UNITED STATES PATENT AND TRADEMARK OFFICE

10/811,408

David H. Stark

Office Action Summary

FIG. 2

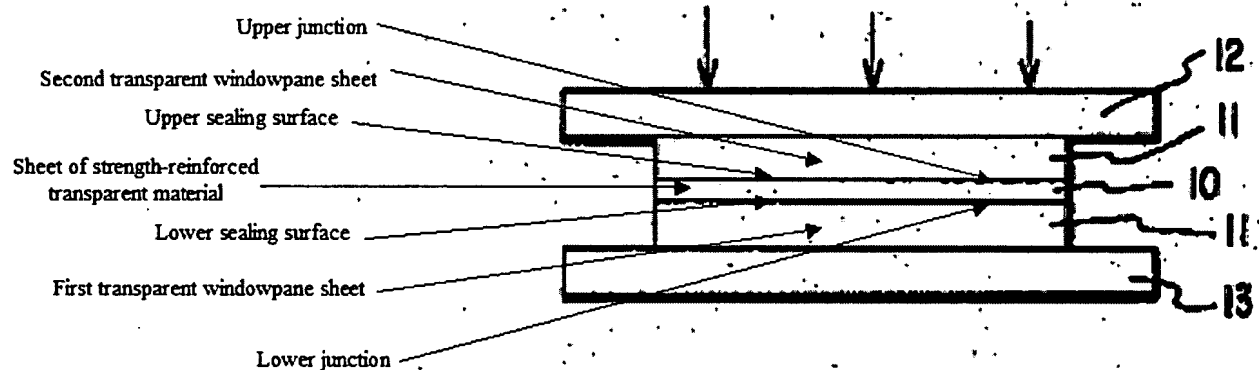
With respect to claim 13 and with particular attention to the reference figure 2 annotated to reflect the applicants chosen lexicon, Martin teaches the following;

1. Providing a sheet of devitrified glass (Column 4, Lines 41- 52) or a "sheet of strength-reinforced transparent material" with upper and lower sealing surfaces as indicated in the figure.

2. Providing first and second transparent windowpane sheets or "Pre-formed bodies of low expansion glasses" disposed in relation to the sheet of devitrified glass in such manner as to produce an upper junction and a lower junction as claimed

3. Applying a predetermined contact pressure at a predetermined temperature (column 4, lines 11-17) in order to achieve a seal or "a diffusion bond" between the first and second transparent windowpane sheets and the devitrified sheet. It is here noted that due to the laminate structure, the central layer of "strength-reinforced material", which is flanked by and protected by the tow outer layers of windowpane sheet material, would reasonably be expected to be more abrasion resistant than the either of said outer layers.

Regarding Applicants newly added limitations, that the materials of construction for layers 10 and 11 in the Martin reference inherently have a tensile strength an impact resistance, and an environmental resistance. As pointed out in Applicants reply filed April 17, 2007, Martin teaches that in a preferred embodiment the layer (10) comprises a lead borosilicate glass comprising 60 to 80% PbO (Column 2, Lines 46-59). To this end, Thorton teaches "lead oxide has been added to glasses and glazes since ancient times" (pg37) and that "lead additions give excellent (radiation) shielding properties to glass" (pg 39). From at least the Thorton disclosure, it is understood that the PbO containing glass would be expected to present a "significantly greater" environmental resistance at least to x-ray and gamma ray emissions.
